FILE	CLIENT
PROPOSED ROUNDABOUT TO NEWGATE LANE EAST VEHICLE SWEEP PATH ANALYSIS - LARGE REFUSE VEHICLE	MILLER HOMES AND BARGATE HOMES

Project No: ITB10353
Project Title: Newgate Lane, Fareham
Title: Proposed Access off Newgate Lane East, Stage 1 RSA – Designers Response
Ref: MC/ITB10353-014
Date: 6 December 2021

Project Details	
Report Title:	Proposed roundabout from B3385 Newgate Lane East, Fareham, Stage 1 RSA Designers Response
Date:	6 December 2021
Document reference and revision:	MC/ITB10353-014
Prepared by:	i-Transport LLP
On behalf of:	Hampshire County Council

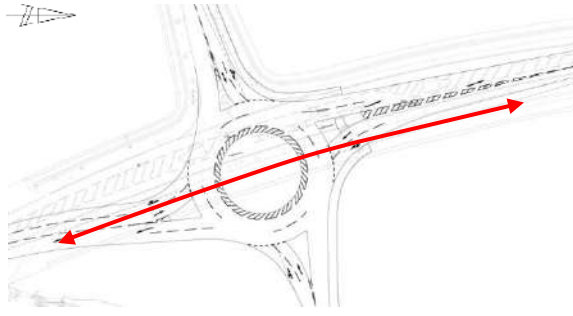
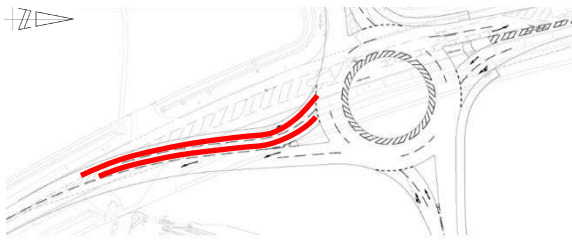
A.1	LOCAL ALIGNMENT
A.1.1	PROBLEM
Location:	Newgate Lane East
Summary:	Traffic may approach the proposed roundabout at inappropriate speeds
Acc Type:	Junction overshoot, heavy braking and loss of control type collisions
<p>Newgate Lane East is a wide two-way single carriageway road that is subject to a 40mph speed limit and according to the Audit Brief observes 85th percentile speeds of 44.3mph and 45.2mph in a north and southbound directions. The proposals that are subject to this Stage 1 Road Safety Audit include the provision of a 50 metre ICD four-arm roundabout at the existing priority junction of Newgate Road with Newgate Road East. The roundabout is to accommodate a circulatory carriageway width of 9 metres with an area of hatching provided around the central island to allow for the swept path of articulated vehicles. The scheme drawings identify that entry deflection on each approach is below 100 metres, however, this is based upon vehicles not entering the hatched area around the central island. The Audit Team have concerns that the area of hatching will not be visible to the driver of a vehicle approaching the proposed roundabout particularly should the road markings fade as they have in proximity to the roundabout junction to the north. An insufficient level of deflection on approach to a roundabout could lead to inappropriate approach speeds and junction overshoot type collisions as well as loss of control as a result of heavy braking.</p>

RECOMMENDATION:	
It is recommended that an adequate amount of deflection is provided on each approach.	
Location Plan:

<p>DESIGN ORGANISATION RESPONSE provided by i-Transport on the 2nd December 2021 following formal issue of this Stage 1 Road Safety Audit on the 22nd November 2021</p>	
<p>Agreed - The overrun area has been revised to provide a kerbed overrun area. This will provide a 25mm upstand and 150mm wide kerb. 1 in 12 return gradient to the central island with white lines and blacktop. The revised scheme is shown on Drawing ITB10353-GA-102 Rev A</p>	
<p>AUDITOR'S VIEW OF DESIGN ORGANISATION RESPONSE dated 6th December 2021</p>	
<p>Confirmation that the overrun area is to be formed with a 25mm upstand should ensure that the level of deflection is clear to approaching drivers at all times and addresses the road safety concern raised at this stage.</p>	
A.2	GENERAL
A.2.1	PROBLEM
Location:	Newgate Lane East
Summary:	No details of the proposed drainage have been provided at this stage
Acc Type:	Sideswipes and loss of control type collisions

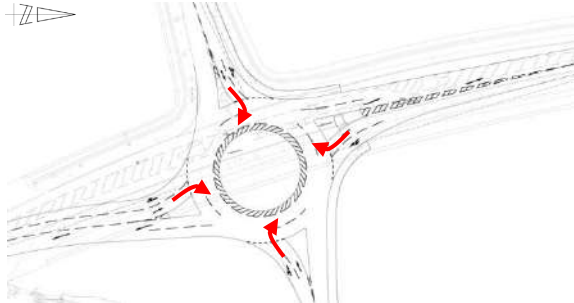
Acc Type:	Junction overshoot, heavy braking and loss of control type collisions
<p>Newgate lane East is a wide single carriageway two-way road that is subject to a 40mph speed limit and observes a traffic flow of circa 2400 during the morning and afternoon peak hours. The proposals that are subject to this Stage 1 Road Safety Audit include the provision of a four-arm roundabout along Newgate Lane East at the existing Newgate Lane priority junction. The scheme drawings provided with the Audit Brief illustrate that the carriageway width of the northbound Newgate Lane East approach to the roundabout increases to two 3.5 metre lanes from a point 70 metres from the give-way line. Whilst the information included within the Audit Brief identifies that the layout allows for two HGV's to enter the proposed roundabout side by side, no swept path of the approach is included. It is noted that the traffic flow data within the Junctions 10 data also provided with the Audit Brief, shows that the HGV content of southern arm of Newgate Lane East makes up just 2% of vehicles and therefore the likelihood of two large vehicles travelling through the junction side by side is negligible. The Audit Team have concerns that the wide two-lane approach will lead to high speed approaches and be utilised for overtaking manoeuvres leading to heavy braking and loss of control or overshoot type collisions.</p>

<p>RECOMMENDATION:</p>	
<p>It is recommended that the width and length of the two-lane approach is reduced</p>	
<p>Location Plan:</p>

<p>DESIGN ORGANISATION RESPONSE provided by i-Transport on the 2nd December 2021 following formal issue of this Stage 1 Road Safety Audit on the 22nd November 2021</p>	
<p>Agreed - The design has been amended to reduce the width and the length of the two lane approach on the southern side of the roundabout, which is reflected on Drawing ITB10353-GA-102 Rev A, with revised geometries shown on Drawing ITB10353-GA-105 Rev A. Drawing ITB10353-GA-119 has been produced to demonstrate how two 16.5m articulated vehicles can travel side-by-side on the approach to the junction.</p>	
<p>AUDITOR'S VIEW OF DESIGN ORGANISATION RESPONSE dated 6th December 2021</p>	
<p>Confirmation that the northbound approach has been adjusted, addresses the road safety concern raised at this stage.</p>	
A.2.3	PROBLEM
Location:	Newgate Lane East
Summary:	Splitter islands may not be clearly visible
Acc Type:	Loss of control and head-on type collisions
